10.0 Steam and Power Conversion System

The information in this section of the reference ABWR DCD, including all subsections, tables and figures, is incorporated by reference with the following departures and supplements.

Figure 10.1-1 Reference Steam and Power Conversion System

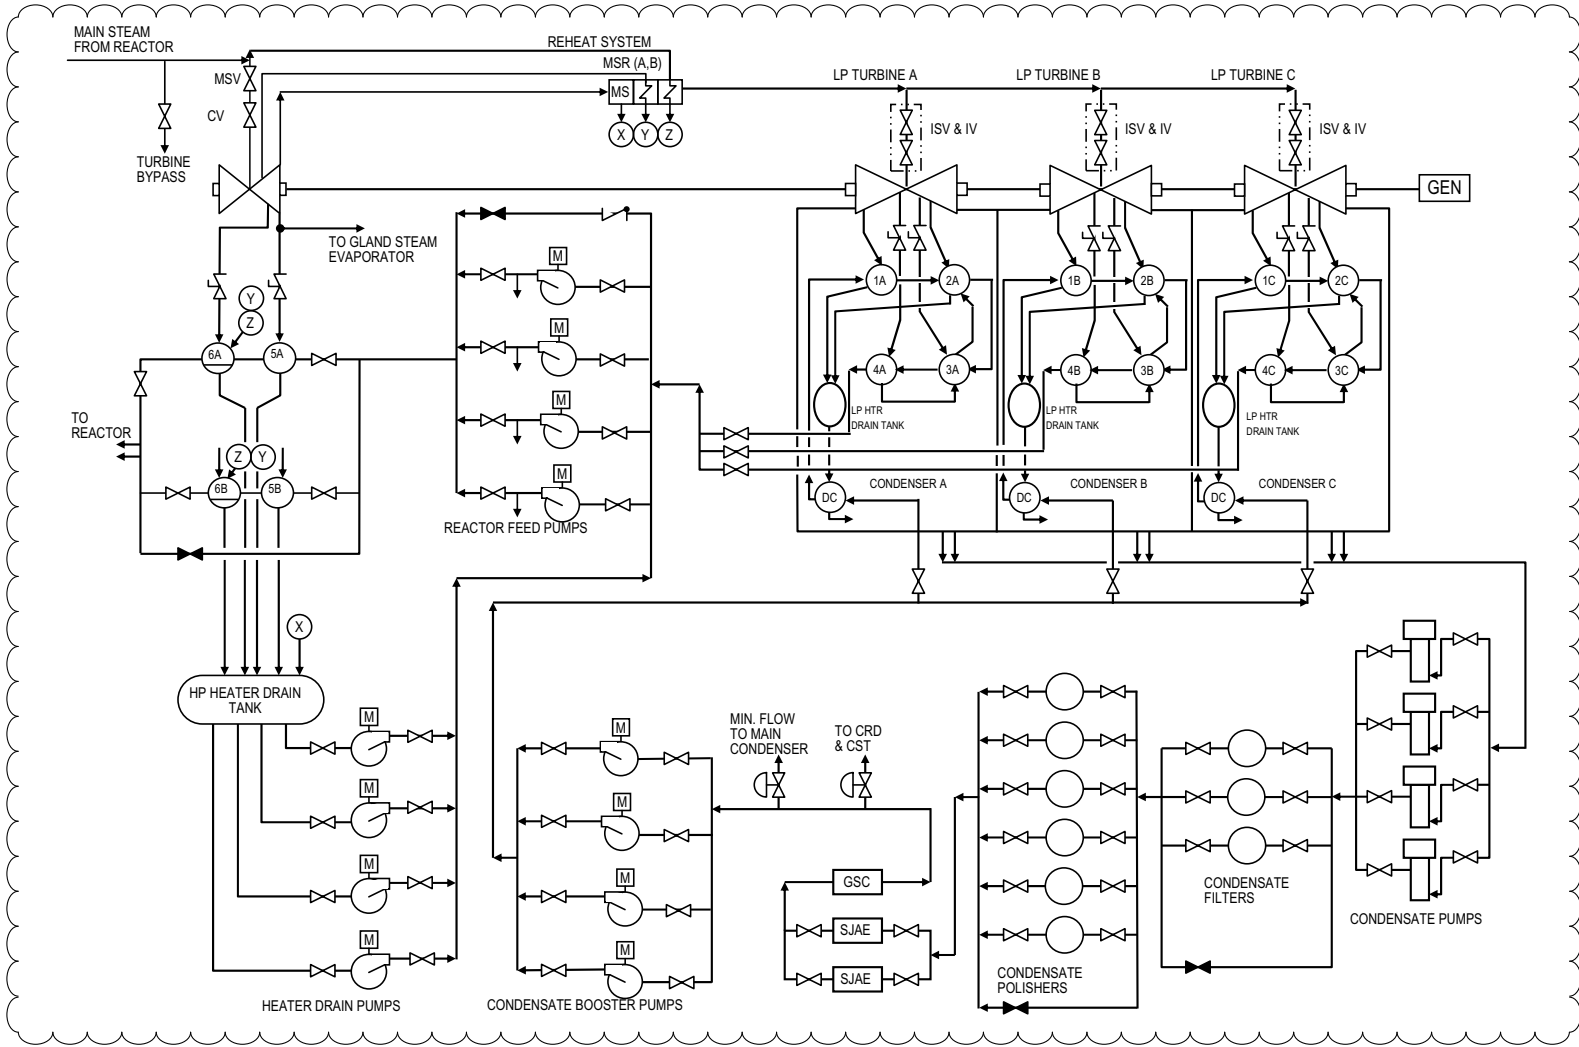
STP DEP 9.2-3 (Figure 10.1-1)

STP DEP 10.1-2 (Figure 10.1-1)

STP DEP 10.2-1 (Table 10.1-1, Figure 10.1-1)

Steam, generated in the reactor, is supplied to the high-pressure turbine and the second stage reheaters of the steam moisture separators/reheaters. Extraction steam from the high-pressure turbine is supplied to the first stage reheaters of the moisture separators/reheaters. Steam leaving the high-pressure turbine passes through a combined moisture separator/reheater prior to entering the low pressure turbines. The moisture separator drains, steam reheater drains, and the drains from the two high pressure feedwater heaters are pumped back to the reactor feedwater pump suction by the heater drain pumps. The low pressure feedwater heater drains are cascaded to the condenser.

Steam exhausted from the low-pressure turbines is condensed and deaerated in the condenser. The condensate pumps take suction from the condenser hotwell and deliver the condensate through the filters and demineralizers, gland steam condenser, steam jet air ejector condensers, ~~offgas recombiner condensers~~, and to the suction of the condensate booster pumps. The condensate booster pumps discharge condensate through the low-pressure feedwater heaters to the reactor feed pumps. The reactor feed pumps discharge through the high pressure feedwater heaters to the reactor.
